## October 2025 planning decisions

## Appendix - Land at Old Ham Lane Lenham

Comment:25/504030/NMAMD Land At Old Ham Lane Lenham Maidstone Kent

Plots 78-81

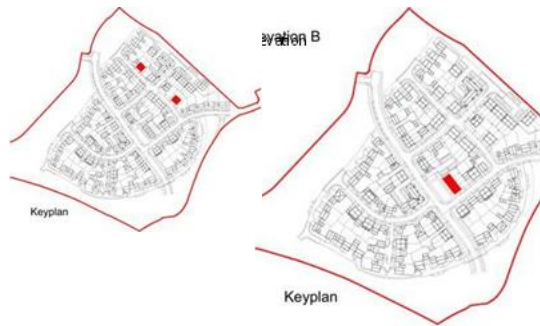
Surely such an increase cannot really be regarded as an NMA. Possibly one of the clearest examples of how this is not an NMA is in units 78-81. We have included this on page 5 of the separately attached submission. We have checked and the two clipped images are to scale. However, it is clear to see that in this example, the building has grown in length, has a stepped roof, is missing detail such as the porch on the right-hand flank wall.

This might be better perceived by the next page (also clipped below) where we have overlaid to the two drawings: Part of the roof step (arising from topographical issues) is achieved by lowering the pitch of the roof to create a step sufficient to accommodate the necessary robust details/flashings. The overall height of this unit is 100mm lower than the approved plan achieved through adjusting the roof pitch. The lengthening of the build unit is clear to see at both ends and with the omitted porch to the right. Worth noting that in the comparison attached, the focus is on the front elevation of each unit. However, there are changes to flank and rear elevations too. For the apartment blocks (the last page in the attached) the changes are less obvious but still there is impact in the overall height of the building. For some reason there is a change to the doors arrangement to the Juliet balconies - moving from equal pairs of doors in the traditional style to an excentric arrangement which affects the overall composition. The detail here is being lost compared to that which was set out in the planning application and is precisely why LPC sought and obtained the detail within the adopted Lenham
